Our Ref NCA/8/2019

27 Apr 2020

COUNCIL SUBMISSION
SSD 10383 – 2 Darcy Road, Westmead
Westmead Catholic Community Education Campus

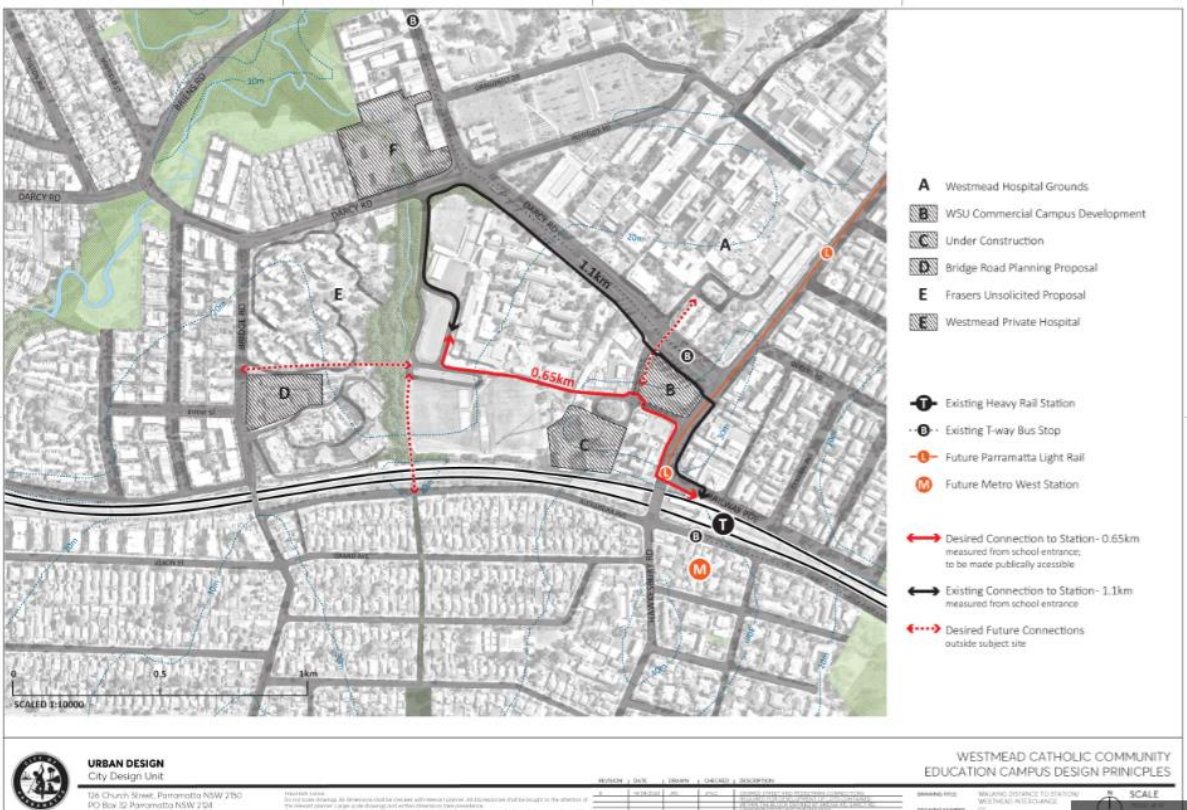
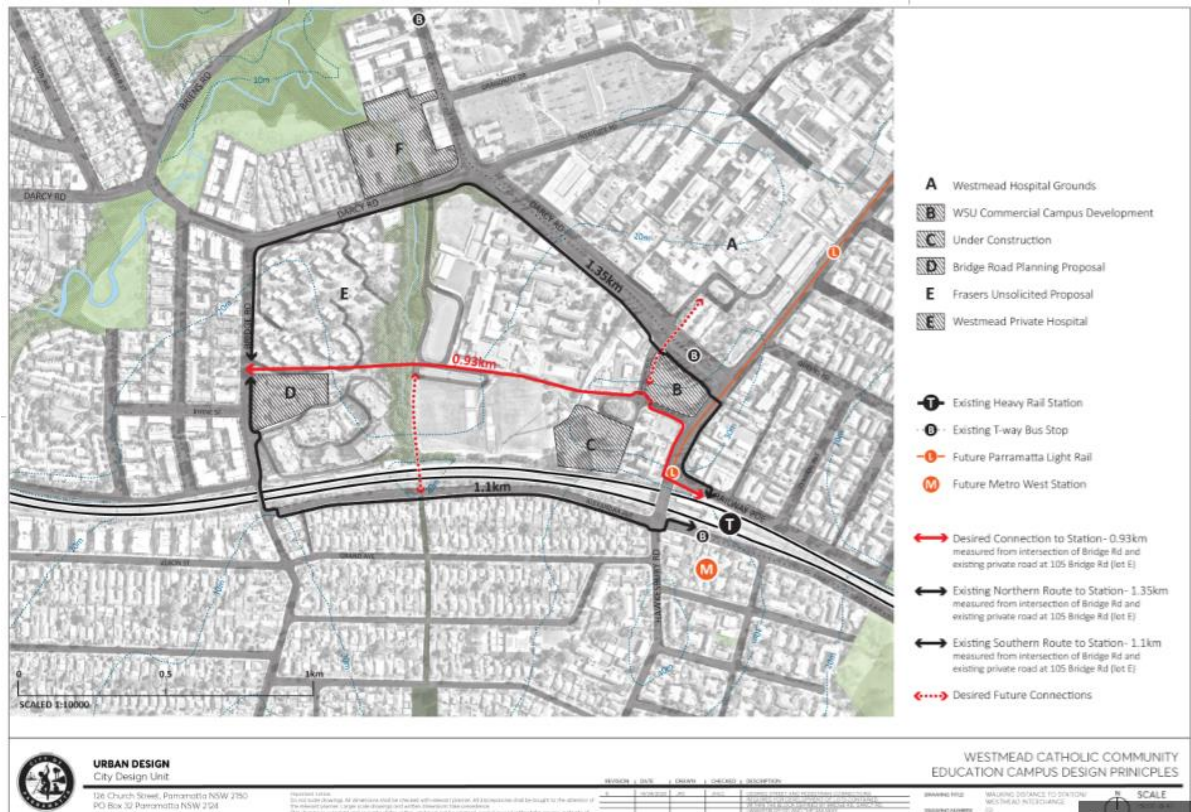
An alternative access to this site is required between the school buildings and the playing fields that can be connected to Farmhouse Road South to the east and Bridge Road to the west.

The street block in which the school is located is bounded by Hawkesbury Road, Darcy Road, Bridges Road and the railway. It is extremely large and not conducive to walking. With the introduction of the light rail and potentially the Metro it is essential that publicly accessible streets and/or shareways are introduced to reduce the size of this block and provide better connectivity to the public transport. The Draft Westmead Innovation District Masterplan sets out a vision for a connected precinct and includes a number of principles, included at Attachment 1, that highlight the importance of an appropriate street network.

Farmhouse Road South is a new street at the eastern end of this block that connects directly to Hawkesbury Road. On the western end there is the potential to connect to Bridges Road as redevelopment of these sites take place. The sketches included below illustrate the difference in distance and improved accessibility a new shareway can make. It should also be noted that the topography is such that a new path between the school buildings and the playing fields provides a more level access to Hawkesbury Road than via Darcy Street. It also has the potential to have canopy trees and provide a far less hostile environment than Darcy Road.
